SYDNEY NORTH PLANNING PANEL ASSESSMENT REPORT

Panel Reference	2015SYW189
DA Number	DA0418/15
LGA	Ku-ring-gai
Proposed Development	Demolish structures (except dwelling at 25 Bushlands Avenue) and construct a residential care facility, basement parking and landscaping works under the provisions of SEPP (Housing for Seniors or People with a Disability) 2004.
Street Address	25, 25A and 27 Bushlands Avenue, Gordon
Applicant	Australian Nursing Home Foundation C/O Mark Boffa
Owner	Mei Mei Tse, Mr Bernard Tse, Ms Monica Chu, Mr Andrew Gock, Ms Ellen Louie
Number of Submissions	Original DA: 108 submissions and a petition with 11 signatures objecting to the proposal. 227 submissions (predominantly form letters) and a petition with 8,803 signatures in support of the proposal. Amended DA: 64 submissions objecting to the proposal and 1 submission in support
Regional Development Criteria (Schedule 4A of the Act)	'General development over \$20 million'
List of all relevant s79C(1)(a) matters	<ul style="list-style-type: none"> • <i>Threatened Species Conservation Act 1995</i> • <i>Environment Protection and Biodiversity Conservation Act 1999</i> • SEPP 55 – Remediation of Land • SREP (Sydney Harb

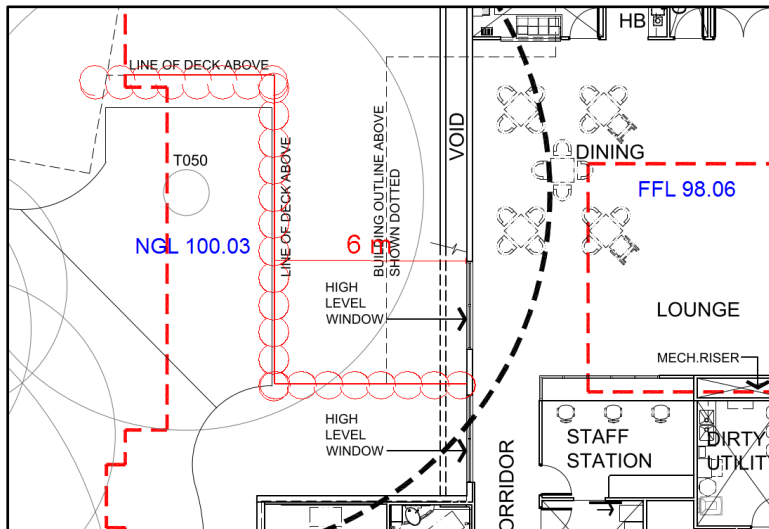
The dining/lounge room on the lower ground floor level of the West Wing has a finished floor level of RL 98.06 which is approximately 2m lower than the existing ground level. The dining/lounge room has one north facing highlight window that is located underneath the deck and lounge room of the floor above. These structures project 6m in a northerly direction beyond the alignment of the window.

As a result of the proposed finished floor level and location of the window, the dining/lounge room will not receive any direct solar access. Reasonable solar access to the living areas of the lower ground floor level could be achieved by replacing two of the bedrooms at the northern end of the West Wing with a lounge room. A lounge room located in this part of the building would benefit from northerly orientation, good solar access and views of the treed garden at the rear of the site.
